NOTICE OF ADDENDUM ADDENDUM NO. 1 City of Madison, Engineering Department

February 8, 2019

CONTRACT NO. 8238 METRO TRANSIT PHASE 1 – SERVICE LANE ADDITION

G-010

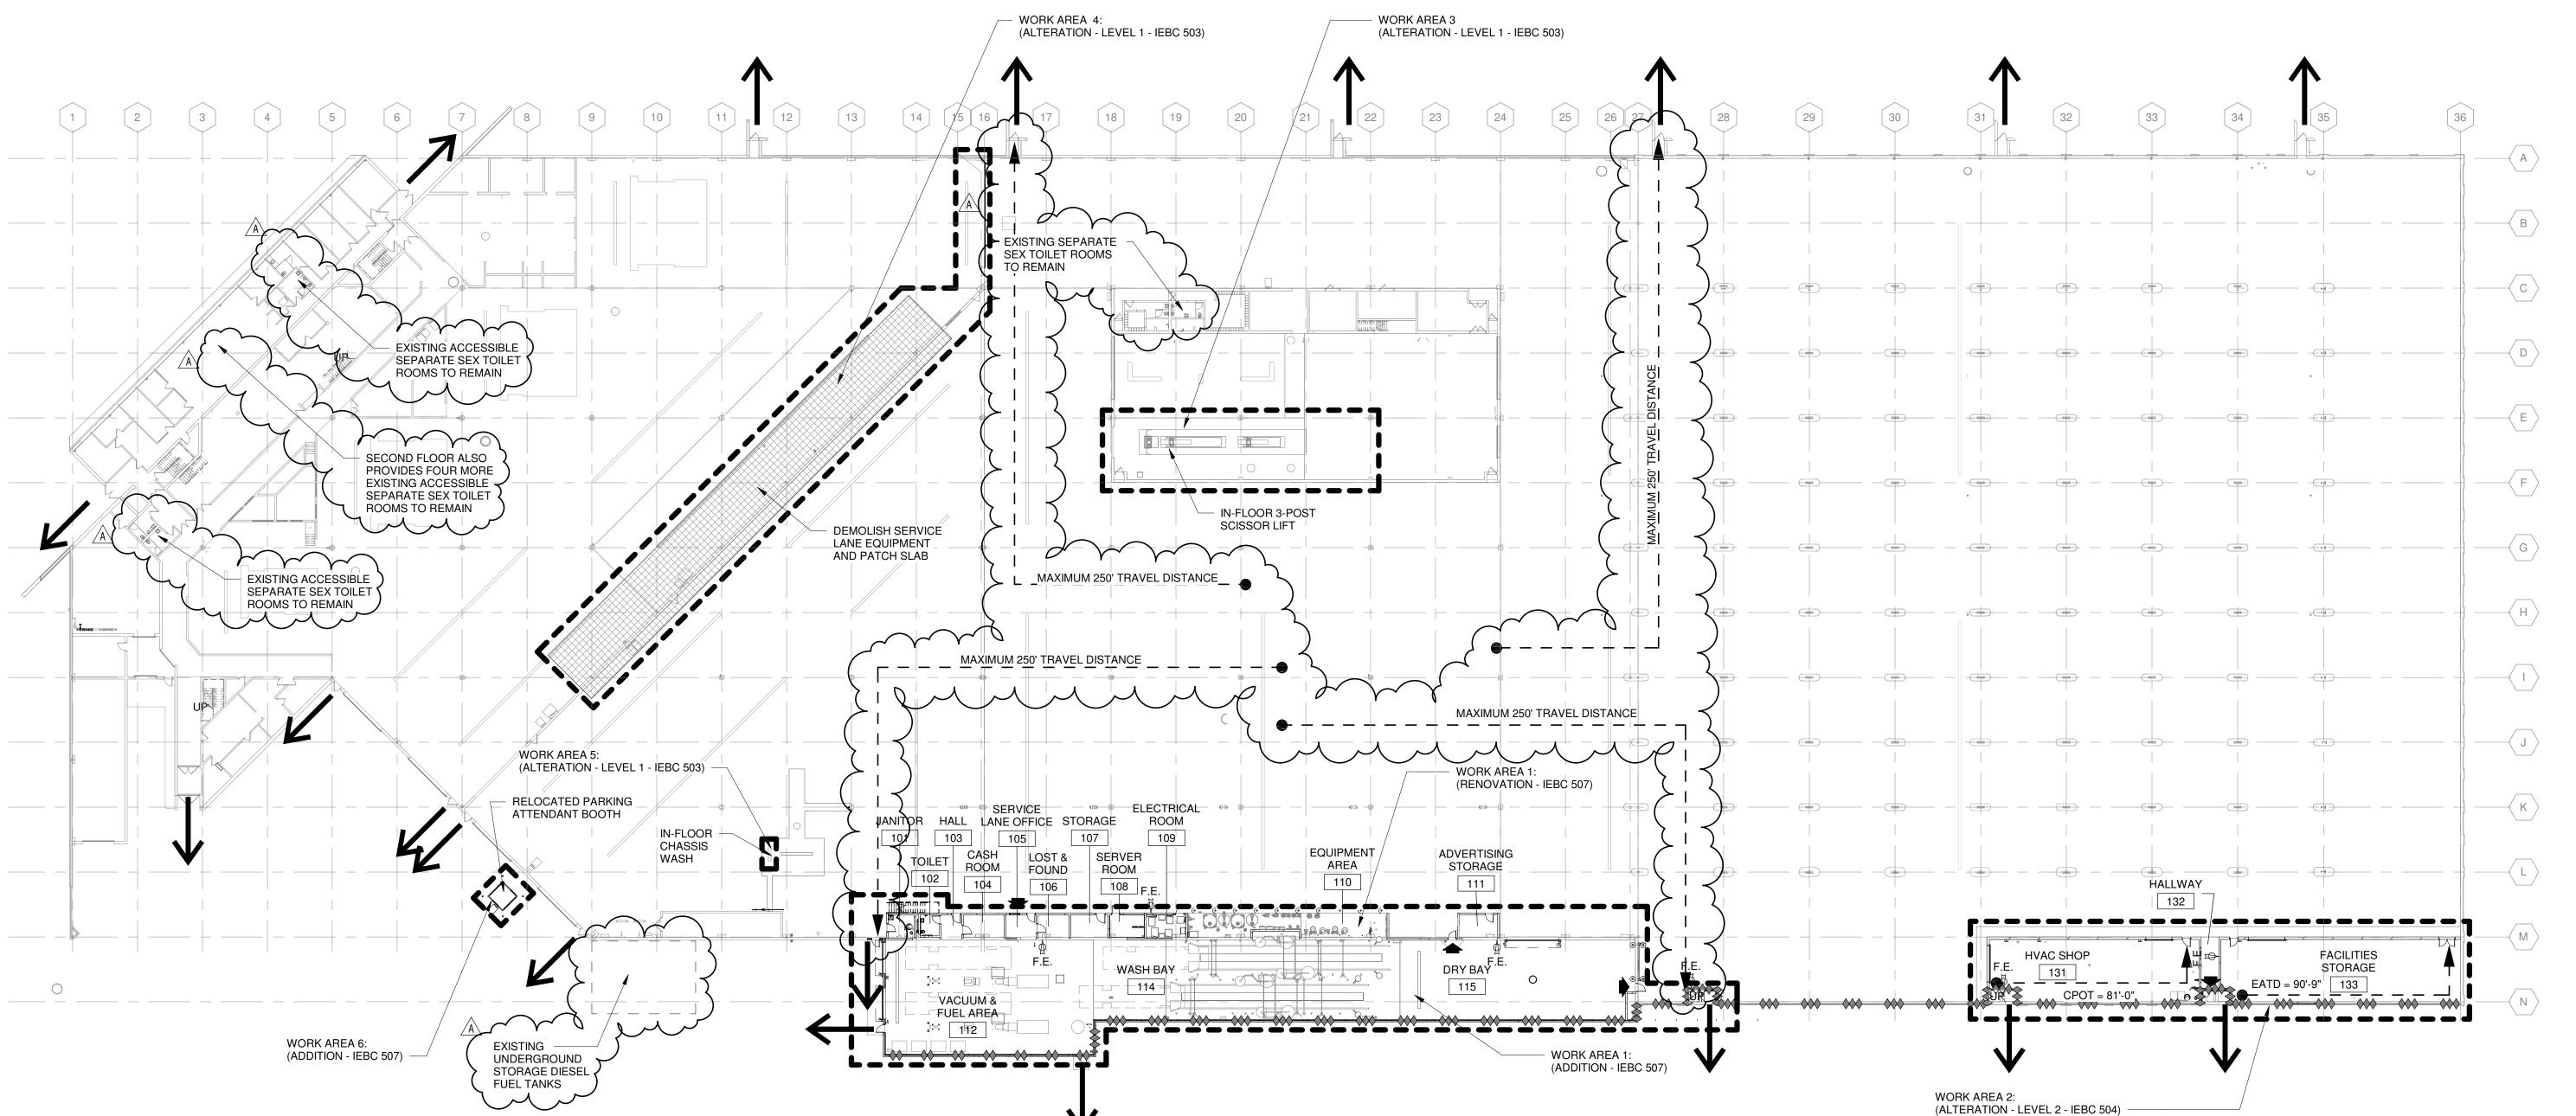
- i. Drawing G-010, (attached) revise code references as shown.
- ii. Drawing G-011, (attached) revise code references as shown.

A-101

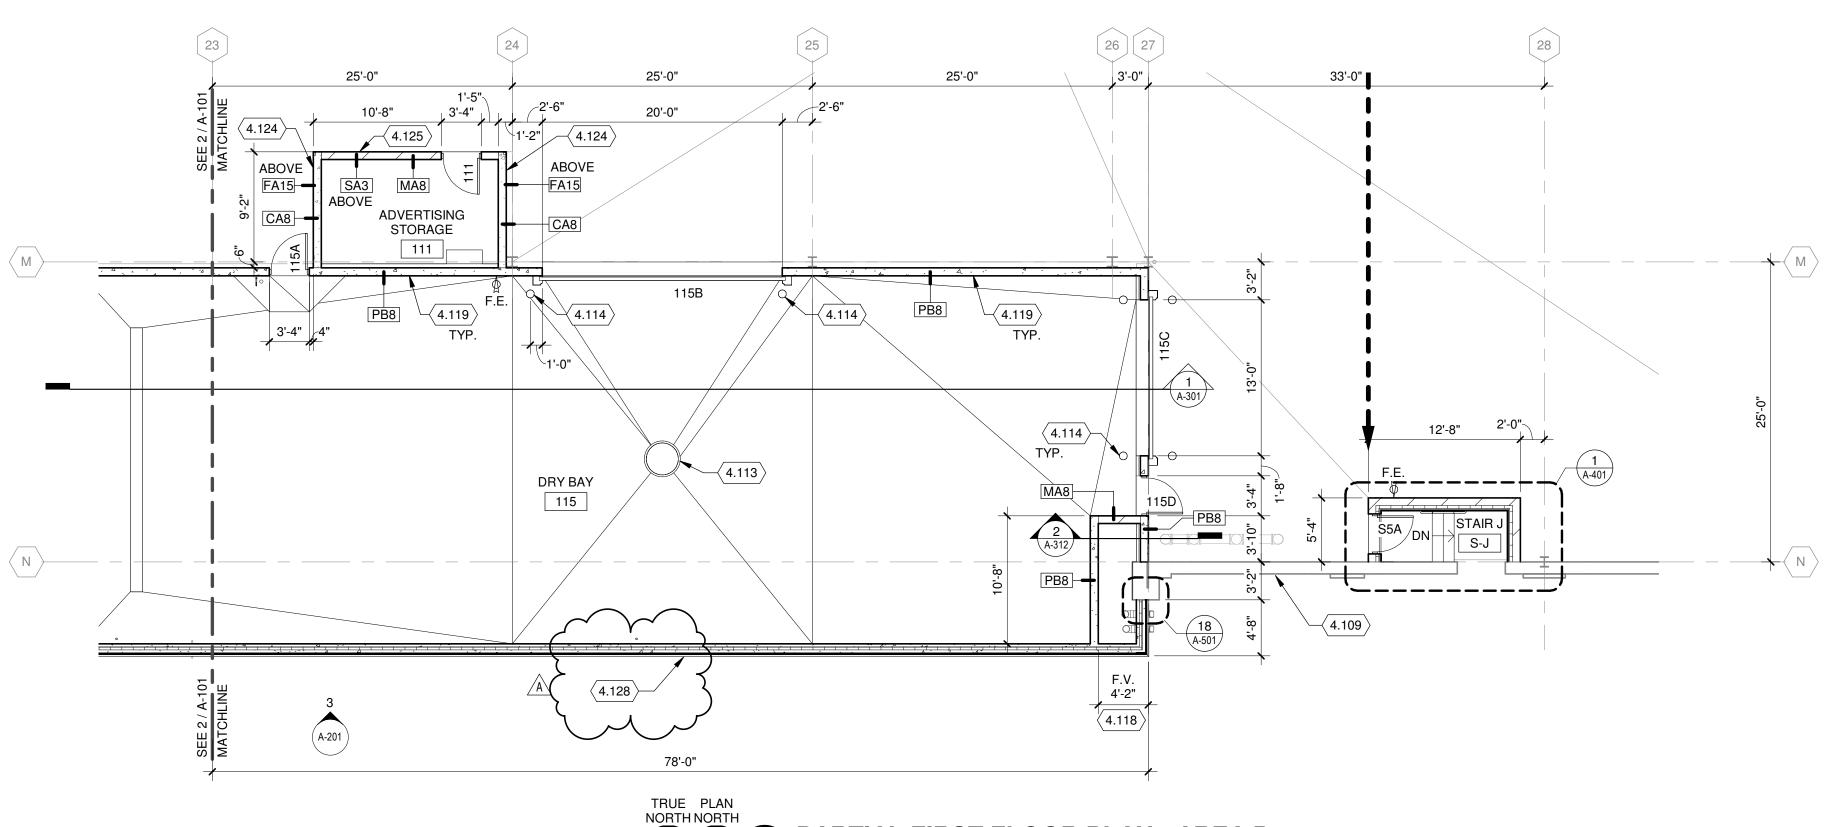
- i. Drawing A-101, (attached)
 - Partial First Floor Plan Area A, 2/A-101
 - o Add note referencing property line warnings as shown.
 - o Revise overhead doors and door numbers as shown.

- Partial First Floor Plan Area B, add note referencing property line warnings as shown.
 - o Keyed Notes, add keynote 4.128.
- ii. Drawing A-301, (attached)

DO NOT SCALE DRA
SHEET CONTENTS
SCHEDULES

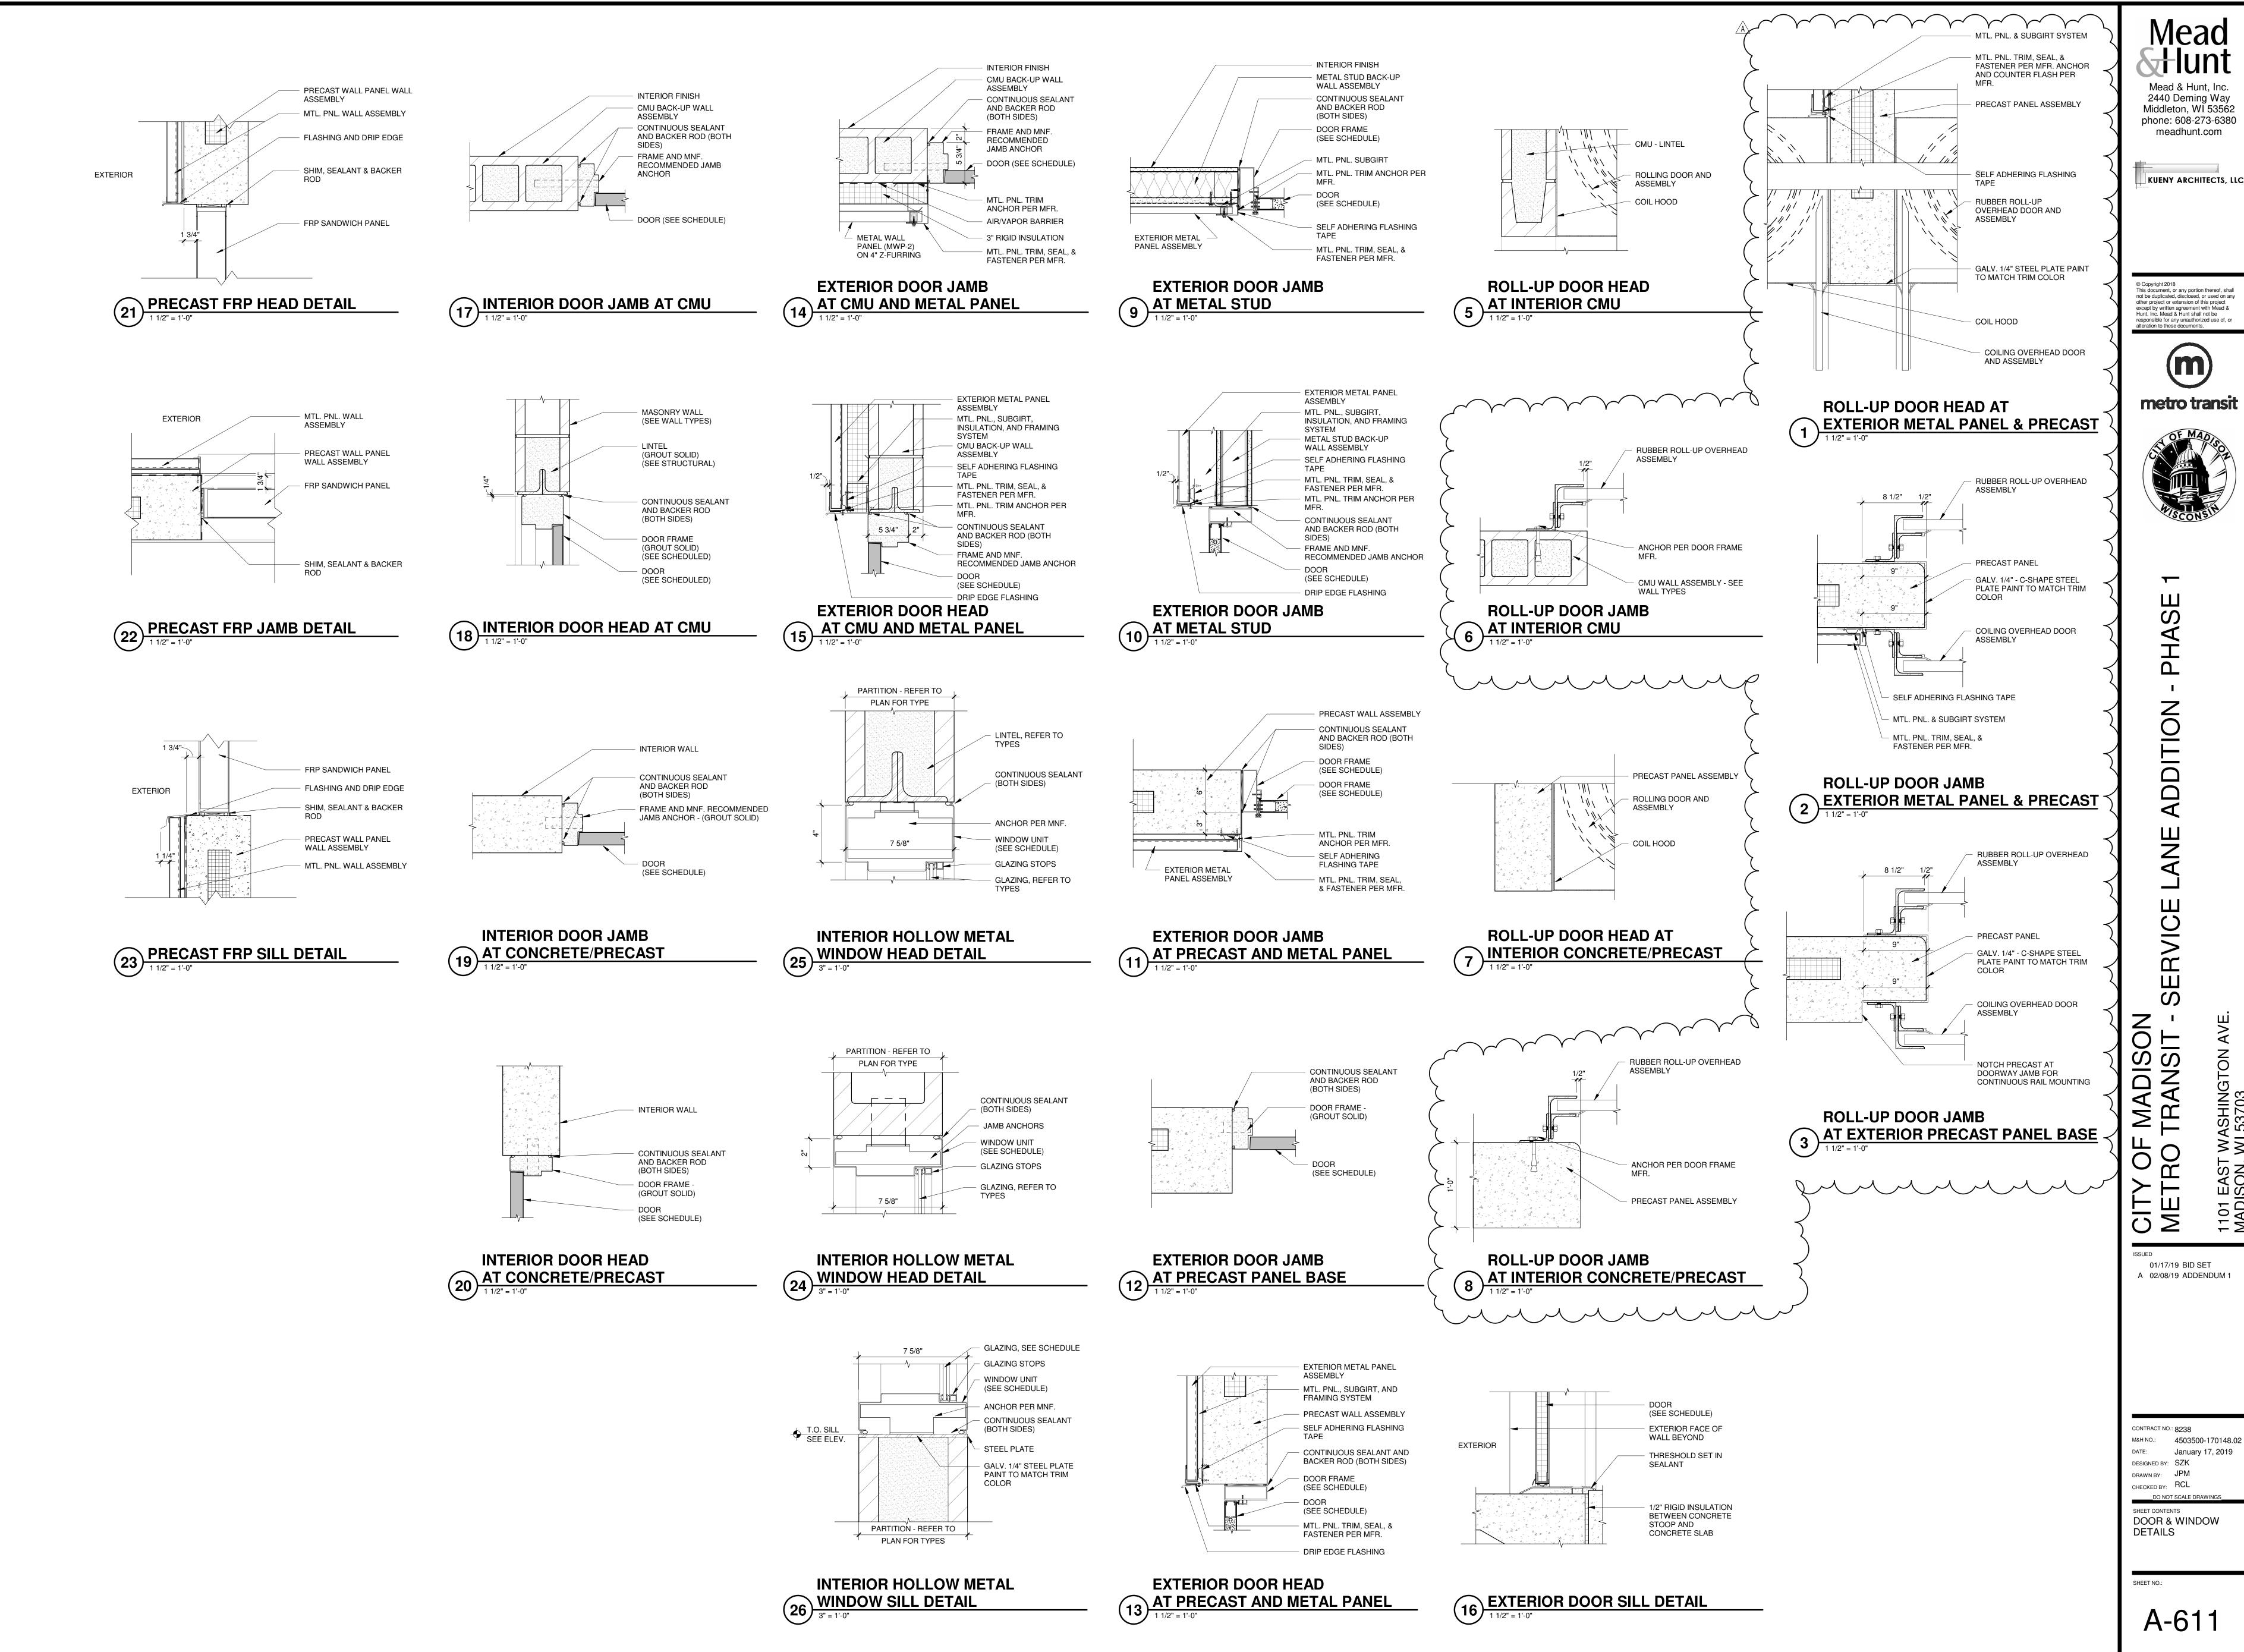
- Revise Door and Hardware schedule as shown.
 - Add new door type RRR Rubber Roll Up Overhead Door.
- v. Drawing A-611, (attached)
 - Revise details 1, 2, 3, 6 & 8, to show revised overhead door requirements.
